Item Name: Crosstube Assembly, Mid Fwd

DART AEROSPACE LTD HAWKESBURY, ONTARIO, CANADA	
DRAWING NO. D206-667-147	REV. A SHEET 1 OF 4
TITLE CROSSTUBE ASSY (206L MID FWD)	SCALE NTS

DRAWING NO. D206-667-147	TITLE CROSSTUBE ASS'Y (206L MID FWD)	REV. A	DART AEROSPACE LTD ENGINEERING ORDER		D.E.O. NO. D206-667-147-A-1	SHEET NO. SHEET 1 OF 1	SCALE NTS
DRAWN <i>Q</i>	CHECKED <i>AS</i>	MFG. APPR. <i>JB</i>	APPROVED <i>MD</i>		DE APPR. <i>MD</i>		
DATE 11.07.15	DATE 11.07.20	DATE 11.07.21	DATE 11/07/21		DATE 11.07.21

DRAWING NO. D206-667-147	TITLE CROSSTUBE ASS'Y (206L MID FWD)	REV. A	DART AEROSPACE LTD ENGINEERING ORDER		D.E.O. NO. D206-667-147-A-2	SHEET NO. SHEET 1 OF 1	SCALE NTS
DRAWN AJS	CHECKED	MFG. APPR.	APPROVED	DE APPR.			
DATE 12.08.02	DATE 12.08.02	DATE 12.08.02	DATE 12.08.02	DATE 12.08.02	DATE 12.08.02

DETAIL P
BONDING STRAP INSTALLATION 2 PL

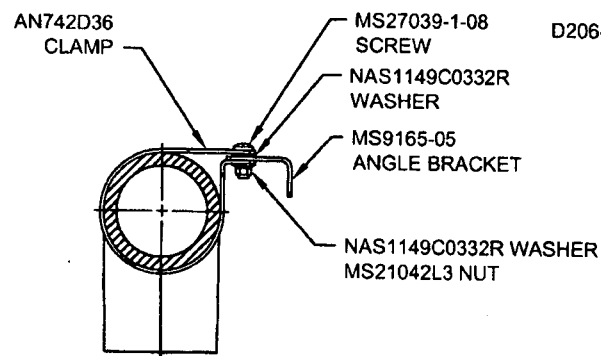
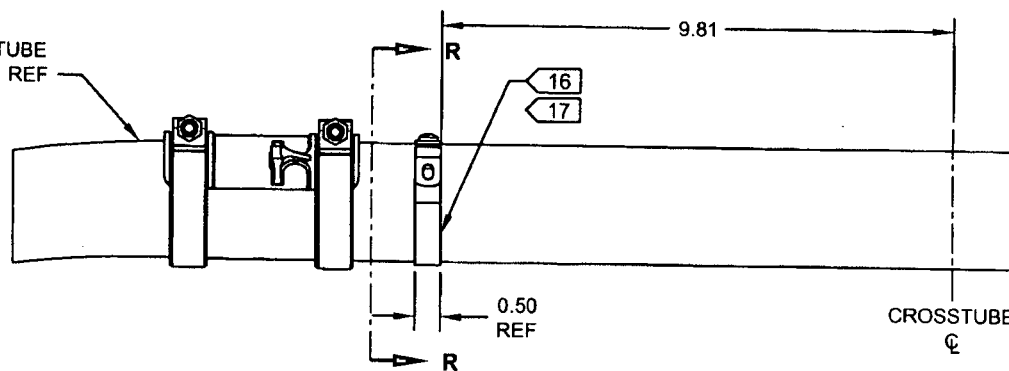
ADD ELECTRICAL GROUNDING STRAP

- 16) MASK AREA UNDER CLAMP PRIOR TO PAINTING
- 17) SEAL EDGES WHERE AN742D36 CLAMP MEETS WITH THE CROSSTUBE USING SIKAFLEX-241/-291 OR MIL-S-8802 CLASS B2 OR PROSEAL 890 SEALANT
- 18) PERFORM RESISTANCE CHECK TO ENSURE MAX RESISTANCE IS 10 MILLIOHMS

ITEM	QTY -147	PART NUMBER	DESCRIPTION
1	X	D206-667-147	CROSSTUBE ASSEMBLY (206L MID FWD)
10	2	AN742D36	CLAMP
11	2	MS9165-05	ANGLE BRACKET
12	2	MS21042L3	NUT (OR MS21042-3)
13	2	MS27039-1-08	SCREW
14	4	NAS1149C0332R	WASHER (OR AN960C10L)
